Re: DIR-2019-1115-CDP-MEL-1A, et al. // CEQA No. ENV-2019-1116-CE
Address: 17440-17444 West Castellammare Drive

WLAAPC Meeting December 1, 2021: Supplemental Submission for Item # 7 and 8: Planning Case No. AA-2018-3776-PMLA-SL-1A, ZA-2018-3779-ZAA-1A, ADM-2018-3775-SLD and ENV-2018-3779-1A

West Los Angeles Area Planning Commission – December 1, 2021 – Agenda items #7 and 8
Appeal Supplemental Submission

West Los Angeles Area Planning Commission – December 1, 2021 – Agenda items #7 and #8
Day-of-Appeal Submission

A1.2

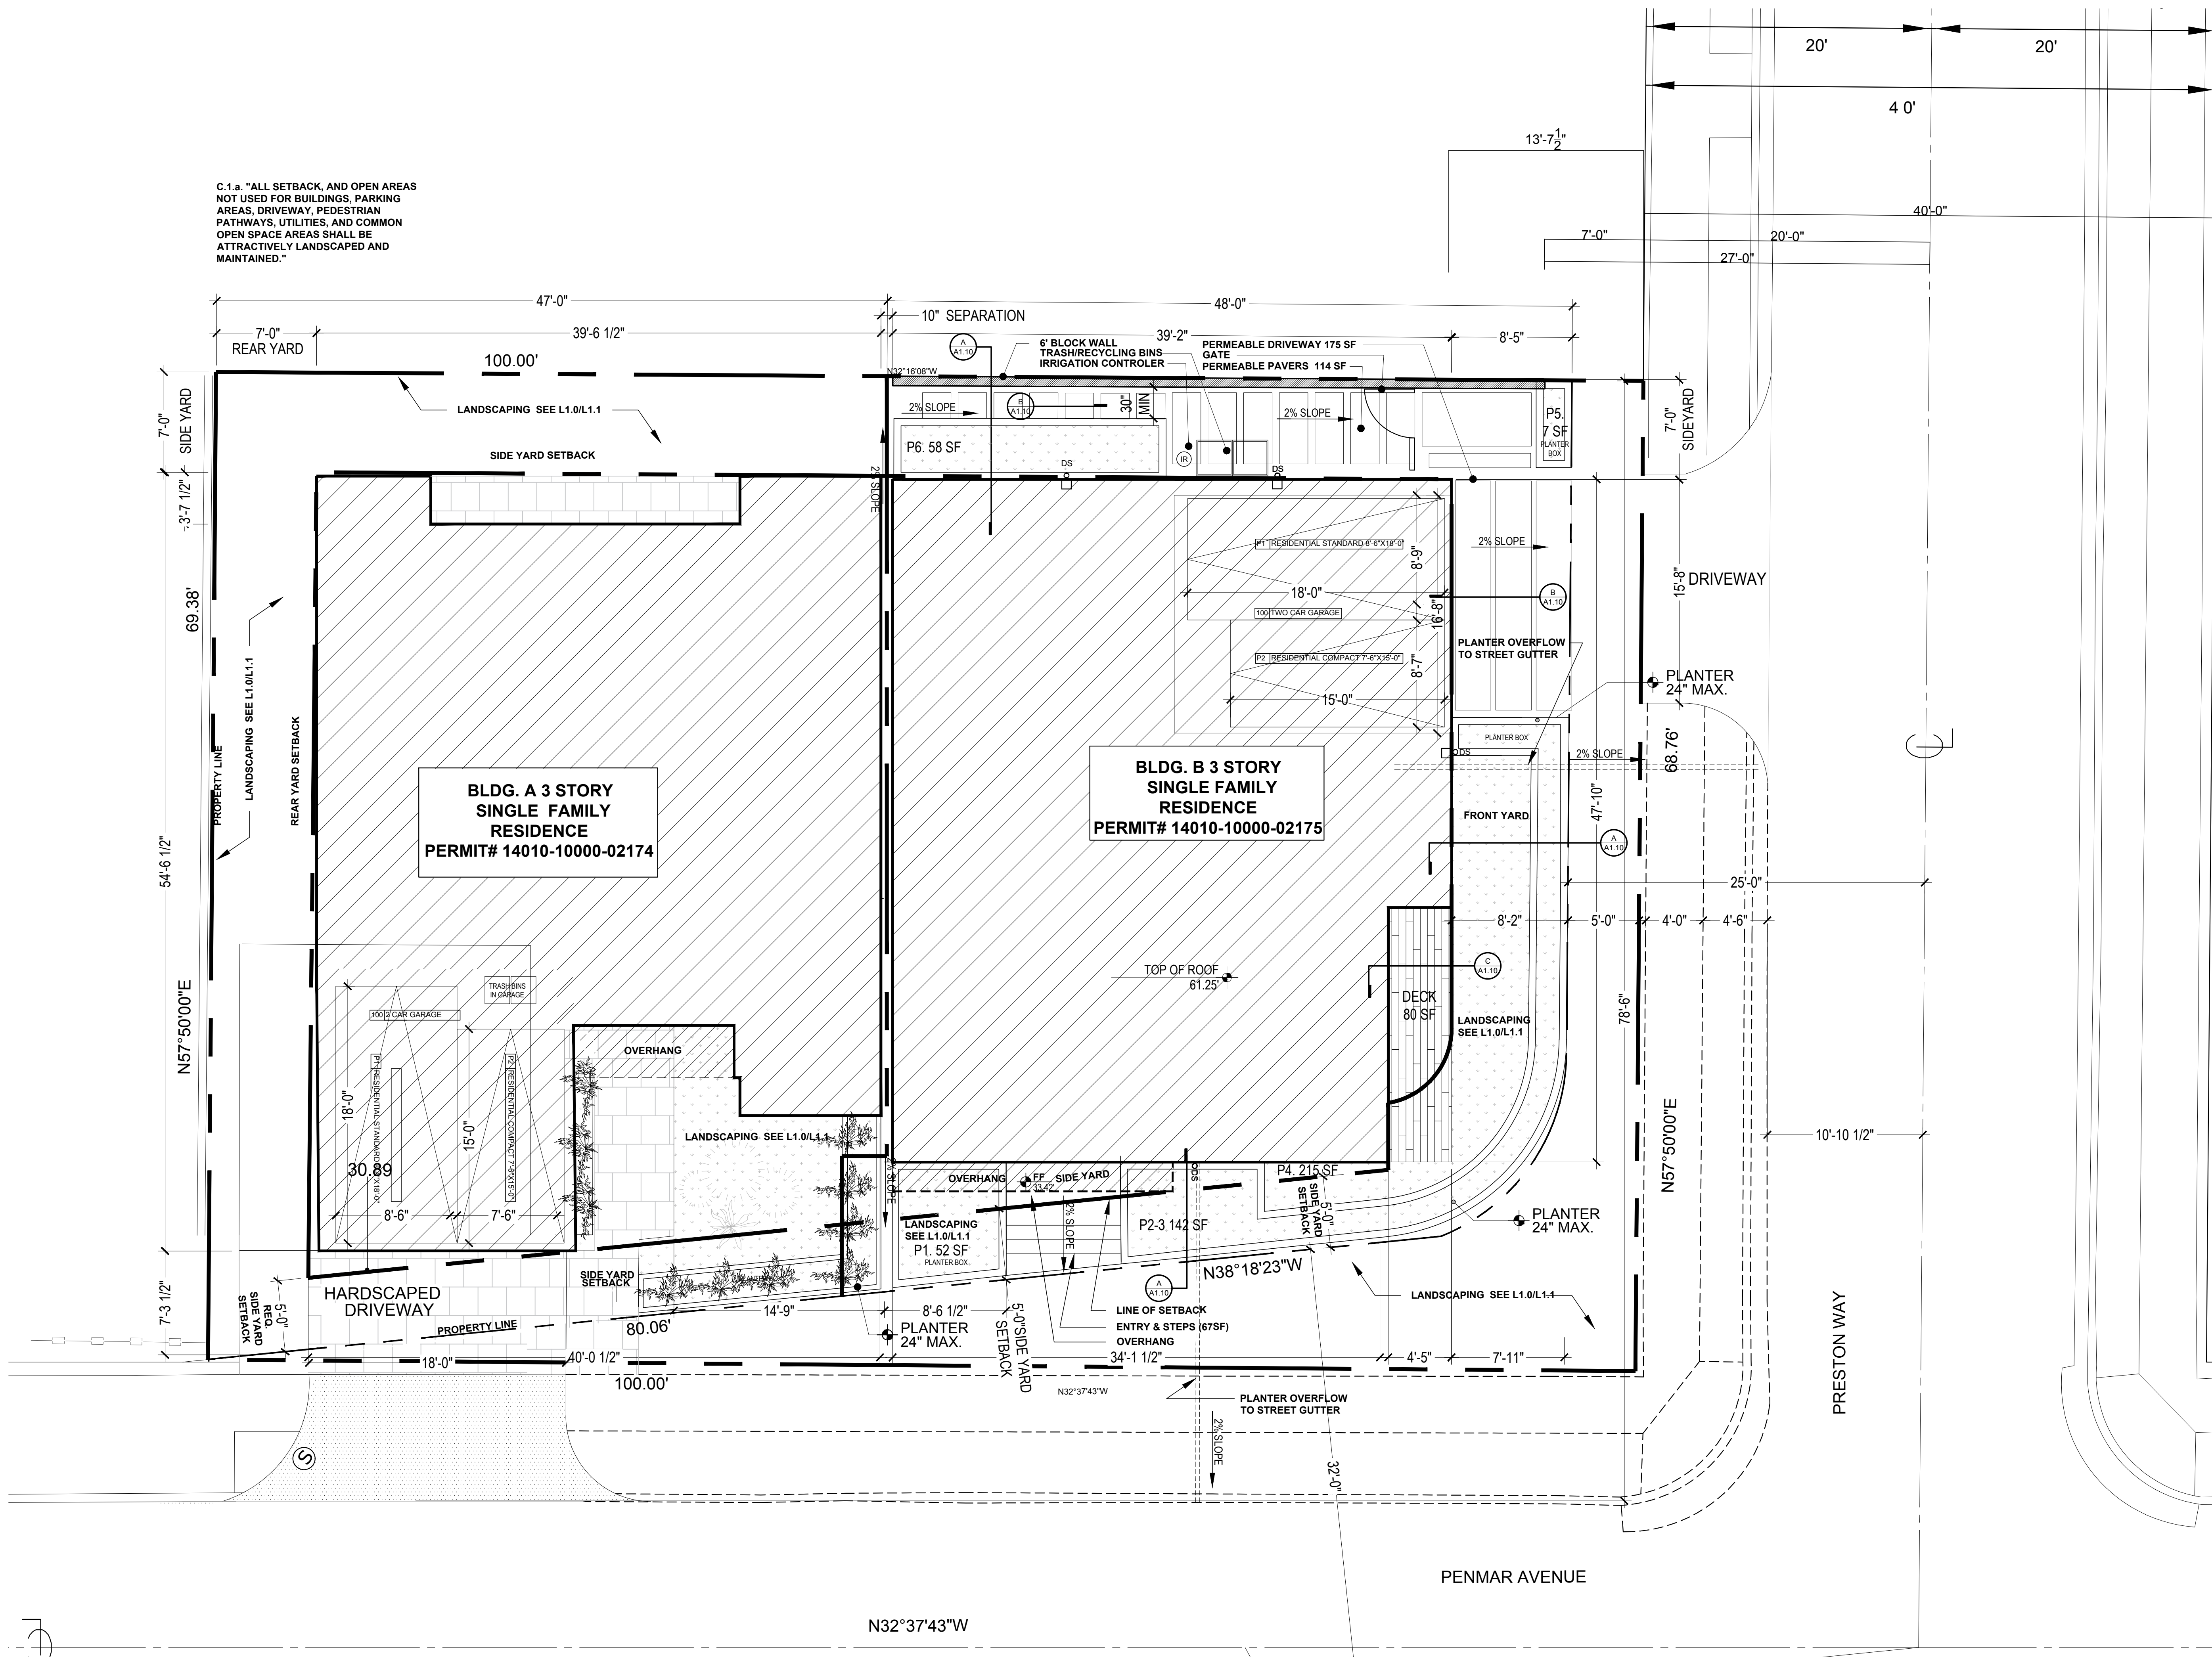
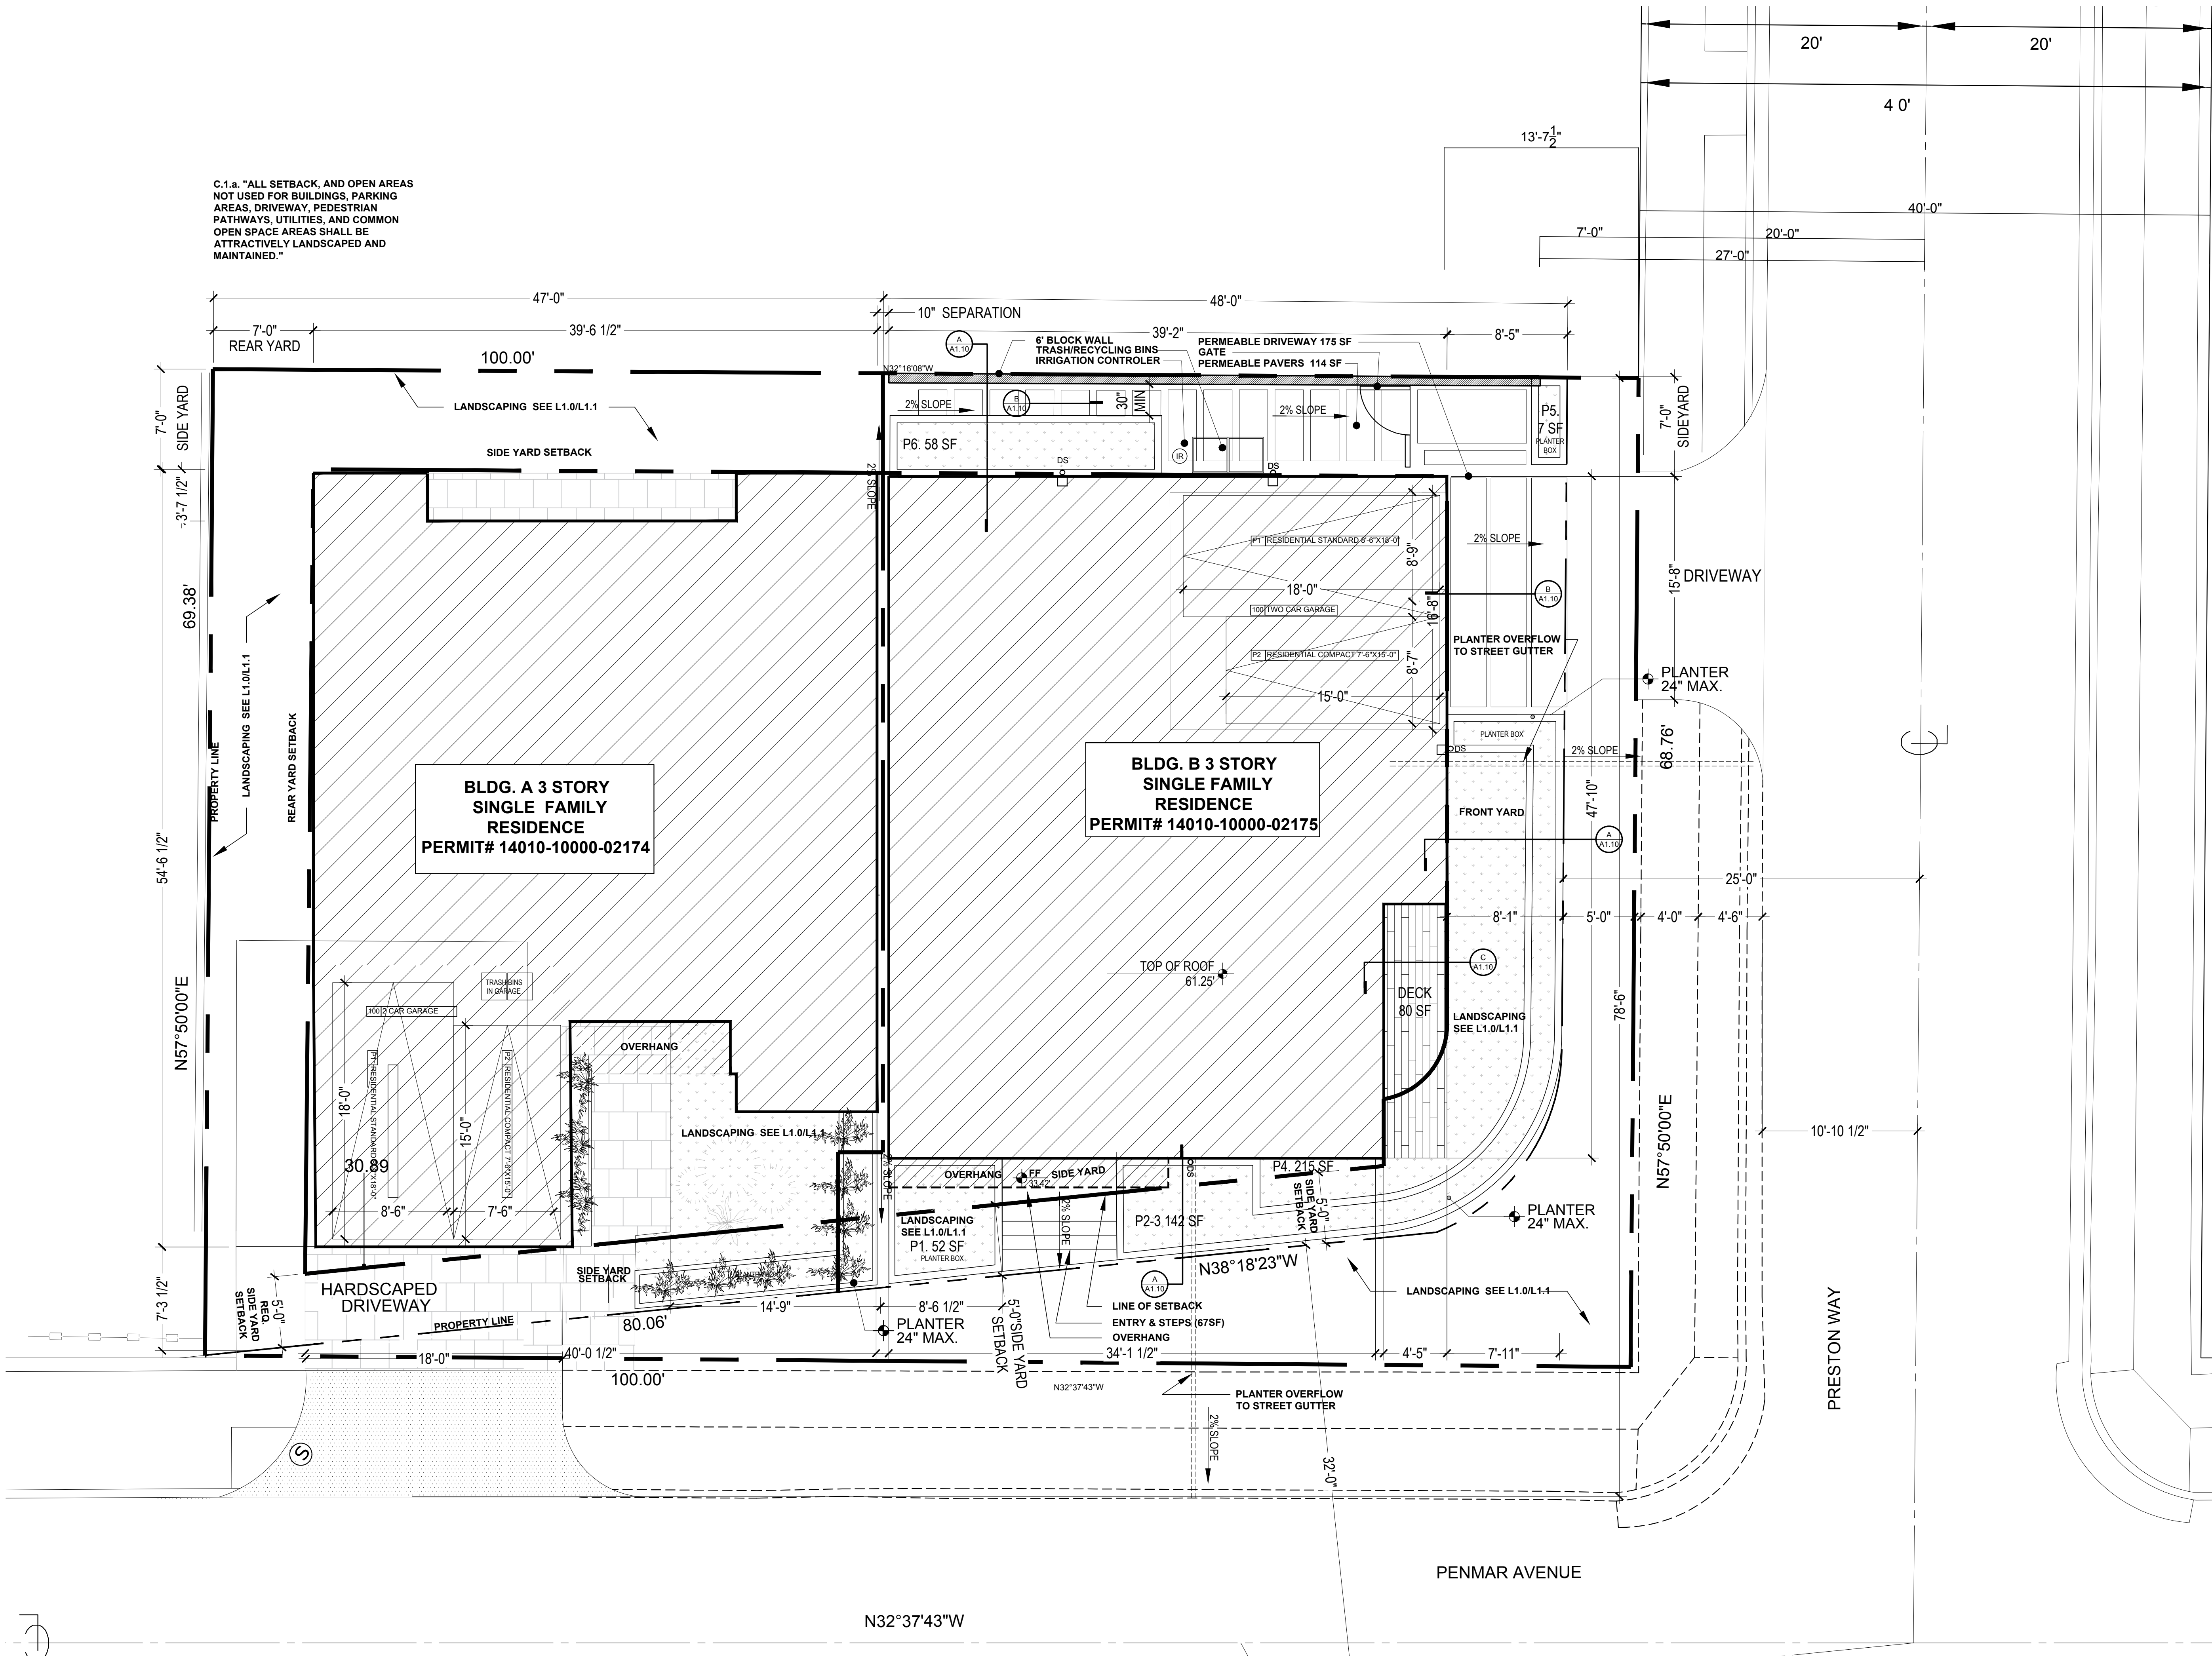
Page 52: A1.2 – The site plan show Building A footprint aligned with the required eastern side setback at 6.42'
